# CITY OF WEST DES MOINES
# STAFF REPORT COMMUNICATION

**ITEM:** Cross Creek, 2475 SE 1st Street – Approve a Preliminary Plat to create twenty-three lots for Single Family Residential development, one outlot and one street lot – Savannah Homes, Inc. – PP-006173 -2023

**Resolution:** **Approval of Preliminary Plat and Acceptance of Parkland Dedication Agreement**

SHEET 4 OF 5

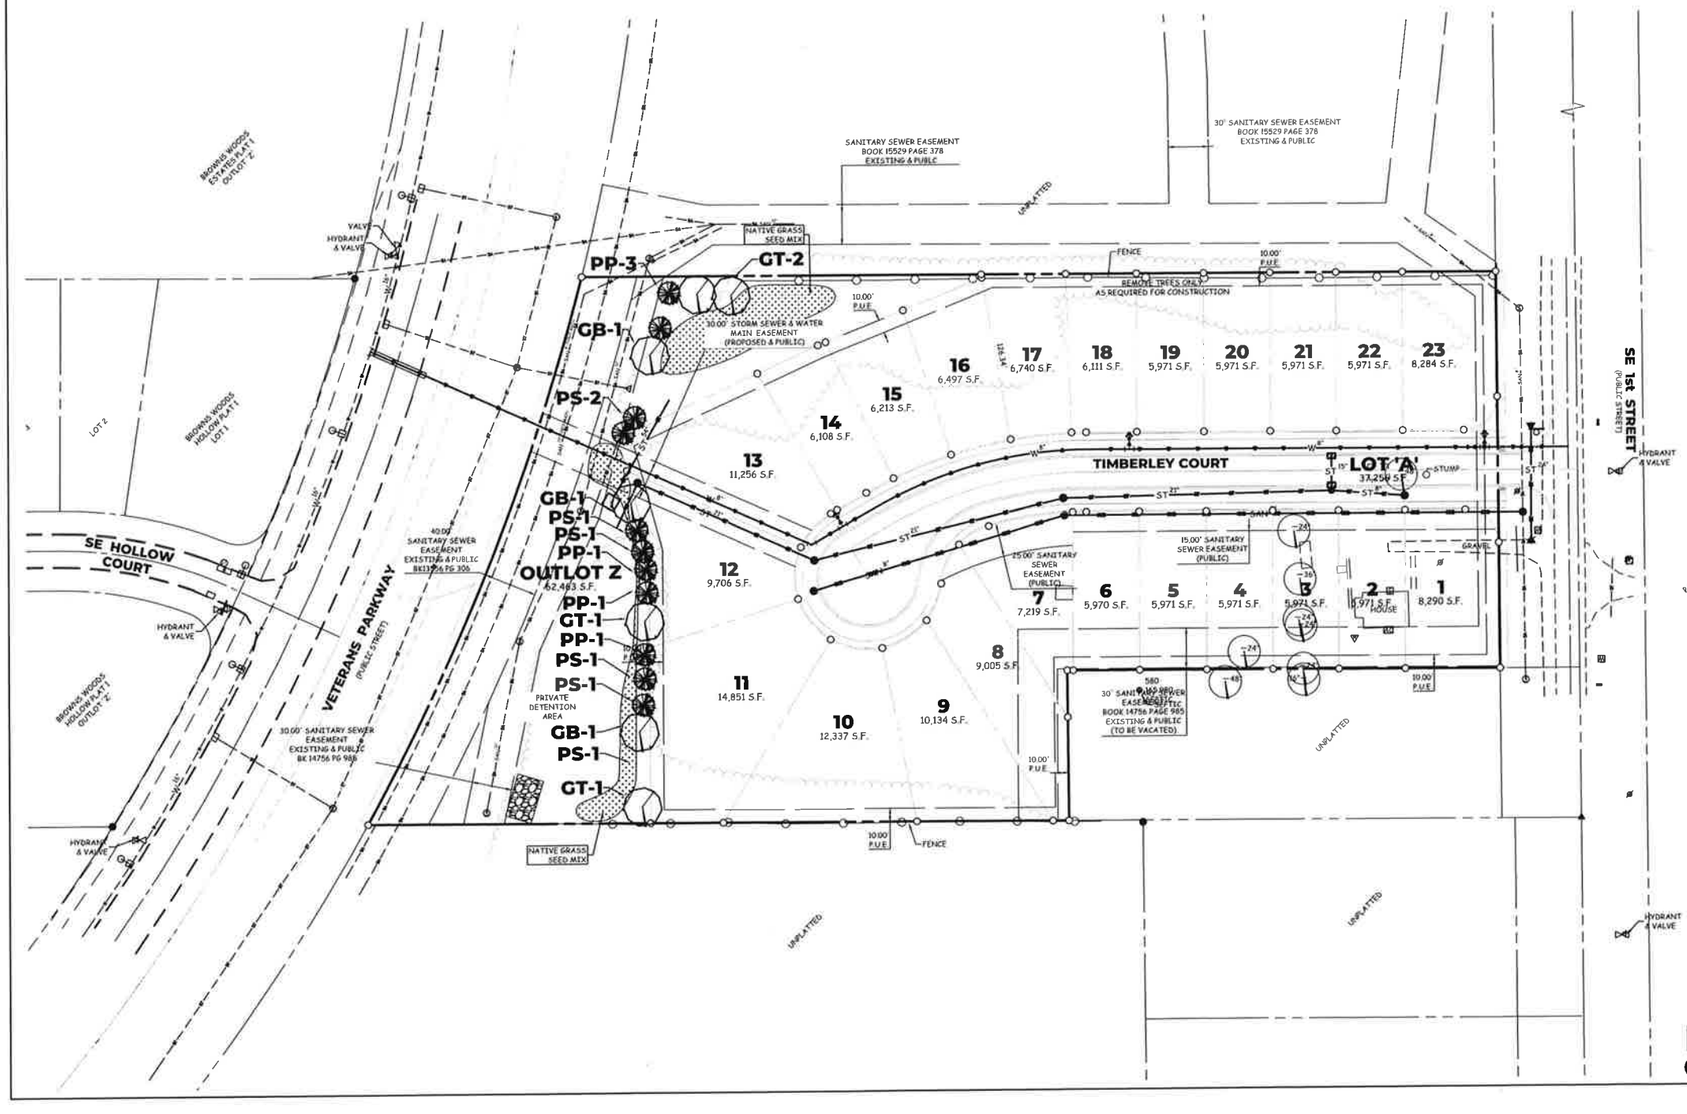
2. Landscape Buffer: A landscape buffer is desired along Veterans Parkway to soften the harshness of pavement at the ultimate width and to mitigate impacts on Lots 11, 12 & 13 of the amount of traffic expected on the roadway. Due to the limited

depth of lot 12, Staff raised concerns with the buffer consuming essentially all of Lot 12's rear yard since no structures, including decks, patios, play structures, sheds, etc. are allowed in a designated buffer. Due to the depth and shape of Lots 11 and 13, the buffer would not have as detrimental effect on the usability of the backyard of these lots. Staff discussed with the applicant about placing the 30' double frontage lot buffer that typically would be located within the private lots, to instead be placed immediately adjacent to Veterans Parkway. However, an existing WRA Sewer easement is located immediately adjacent to the Veterans Parkway right-of-way which prohibits the placement of vegetation within the easement area. Adjacent to the easement are then existing wetlands and the anticipated storm water detention facility for the subdivision (see enclosed exhibit illustrating the location of the Veterans Pkwy, WRA easement and detention/wetland area). Instead of placing the buffer within the individual lots and greatly impacting the usability of the limited rear yard of Lot 12, the applicant would like to request a wavier of the 30' landscape buffer. The request is made not only because of the hindrances of the WRA Sewer Easement and wetlands/ detention areas, but also due to the separation between Veterans Parkway to the rear lot line of lots 11, 12, and 13 (approximately 50' at closest point). The applicant is proposing to locate a row of trees (no shrubs) between the rear lot line of lots 11, 12 and 13 and the detention/wetland area. Given the uniqueness of this situation, Staff agrees with the request as we feel it meets the intent of a buffer on a double frontage lot to mitigate the impact of the roadway on the private lot(s) with the added benefit of not creating a situation in which Lot 12 finds out after constructing the home that they have no rear yard to use as they may wish.

****NOTE: WE ARE REQUESTING A WAIVER FROM THE LANDSCAPE BUFFER DUE TO THE SANITARY SEWER EASEMENT WHICH CONTAINS AN 8" FORCE MAIN AND A 72" FORCE MAIN.

2. City Council granting a waiver of a 30' Landscape Buffer along Veterans Parkway and accepting in lieu thereof the installation of trees in the common area immediately adjacent to the rear lot line of lots 11, 12, and 13 towards fulfilling the intent of the buffer. Said trees shall be installed prior to the issuance of a final occupancy permit for the last dwelling constructed on lots 11, 12, or 13.

# CROSS CREE

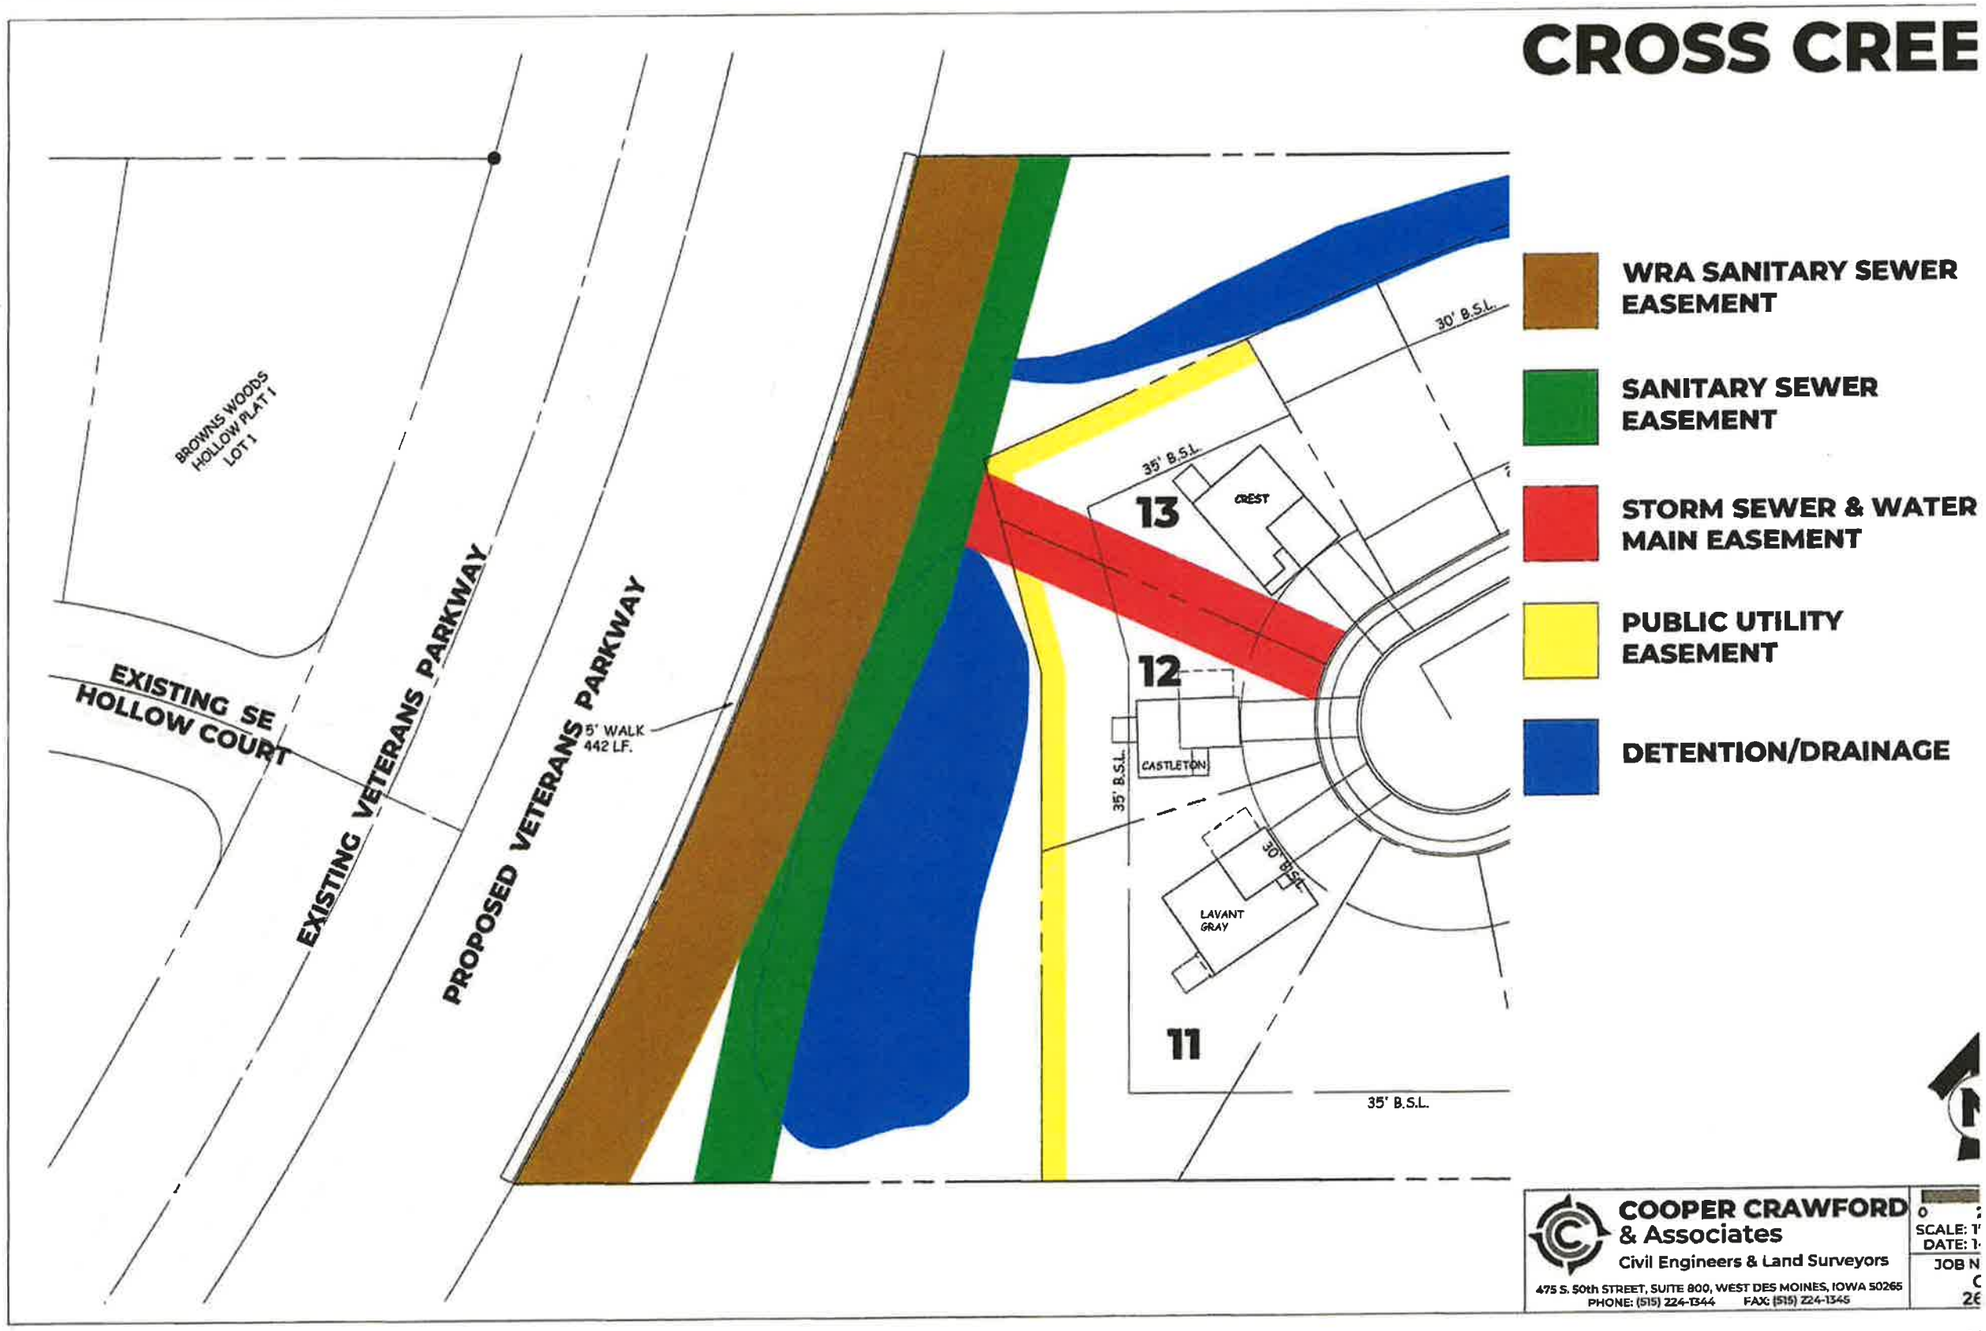
3. Veterans Parkway Sidewalk: Veterans Parkway is currently not built to full width. Widening of the roadway is anticipated in the future. Cross Creek is the first subdivision/development on the east side of Veterans Parkway. There are currently no sidewalks constructed along the east side of Veterans Parkway. The applicant requests deferral of the installation of the Veterans Parkway sidewalk until such time that either Veterans Parkway has been widened and/or development of ground on either side of this subdivision occurs.

While staff agrees that is it premature to install the sidewalk along Veterans Parkway, staff does have concerns that the responsibility will become that of the Homeowner's Association rather than an obligation of the developer. Prior to the presentation of the Final Plat to the City Council, the agreement referred to in code will need to be executed and details of surety to cover the future costs will need to be determined.

3. The City Council granting a deferral of the installation of the public sidewalk along Veterans Parkway until such time that Veterans Parkway is widened, and/or sidewalks are implemented as part of development of ground on either side of this subdivision, and/or the City Council otherwise directs the installation of the sidewalk.
